**BEFORE THE COMMISSIONERS ON BEHALF OF  
THE OTAGO REGIONAL COUNCIL**

Water Permit Application No. RM19.151

**EVIDENCE OF BRYONY MILLER**

Figure 3: Pipe intake at upper Royal Burn North Branch water take. Intake pipe diameter is 330 mm. Outflow of ponding area is shown by blue arrow. Photo taken by Bryony Miller during site visit 13/05/2021.

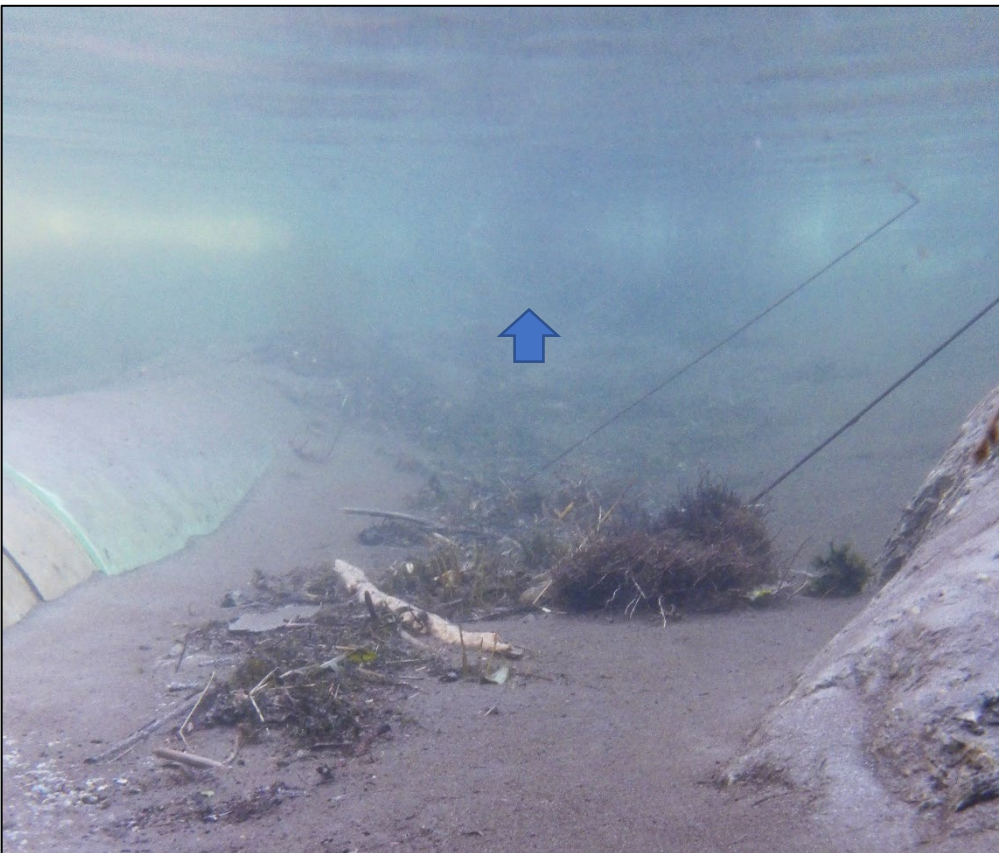
44. The upper take intake pipe was measured to be 330 mm and at the time of site visit did not have additional piping with sediment screen attached (Figure 3). The pipe position in the ponded area, without the additional section of piping with sediment screen, shows that at most, only half of the intake pipe will be submerged in the water column and will naturally allow for residual flows of at least 10 L/s.

45. The additional piping with sediment screen at the upper take was sitting on the bed of the ponded area above the water take (Figure 4). It is unknown why this had been removed and is also unknown the depth at which the opening sits within the water column when it is attached to the intake pipe. However, it looks to be able to be fully submerged. Therefore, when this additional piping is attached water can be abstracted at low stream levels.

52. In order to protect the natural ecological values, in particular EPT invertebrates and trout, and the life-supporting capacity of the creeks via maintenance of water quality parameters, a residual flow comprising of 90% of MALF is recommended at the New Chums Creek take (95696) and the Upper Royal Burn North Branch take (RM14.364.01 & 96285). It is proposed that this can be achieved by using a specific diameter piped off-take through the New Chum weir and flow gauging at
